# UNITED STATES PATENT AND TRADEMARK OFFICE

APPLICATION NO.	FILING DATE	FIRST NAMED INVENTOR	ATTORNEY DOCKET NO.	CONFIRMATION NO.
10/067,992	02/08/2002	Takafumi Nakahama	065905-0248	9942

<b>Office Action Summary</b>	Application No. 10/067,992	Applicant(s) NAKAHAMA, TAKAFUMI	
	Examiner Tho v Duong	Art Unit 3743

### **DETAILED ACTION**

Figure A: The modified figure corresponds to figure 6 with limitation shown.

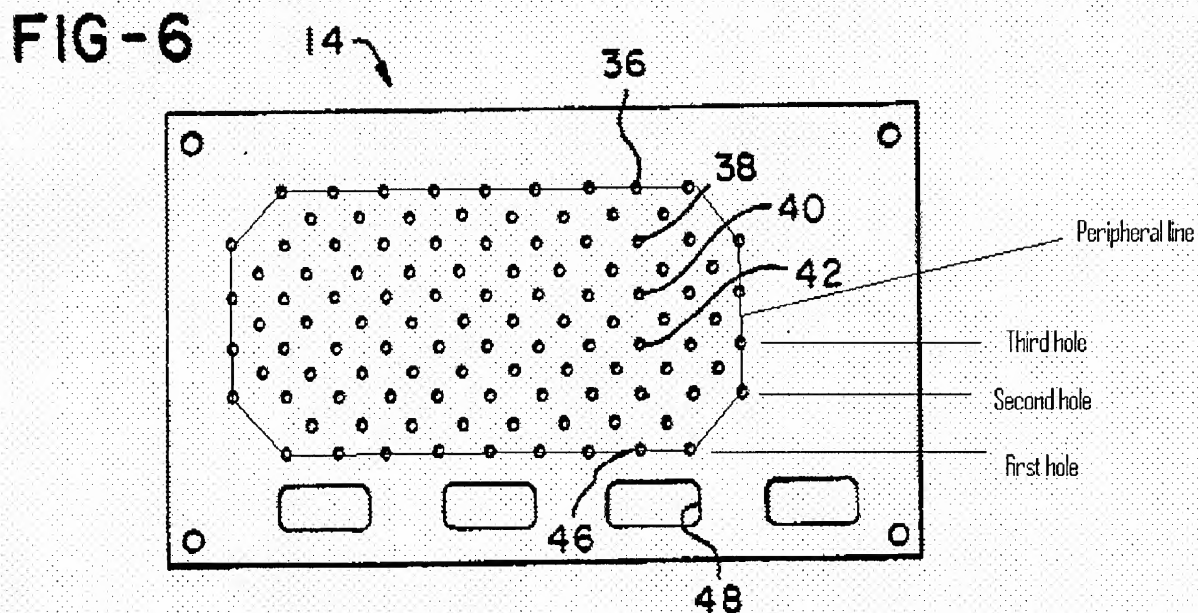
surrounded by the header and the second heat sink member (14); and an outlet port (48 or 34) whereby the coolant in a second space (50) surrounded by the first heat sink member (16) and a second heat sink member (14) is made to flow out. As regarding claim 18, Quon discloses (figure 6 and figure A) that the plurality of holes comprises a first hole, a second hole and a third hole arranged in sequence along a peripheral line without intervening holes and wherein the distance between the first hole and the second hole is different than the distance between the second hole and the third hole.
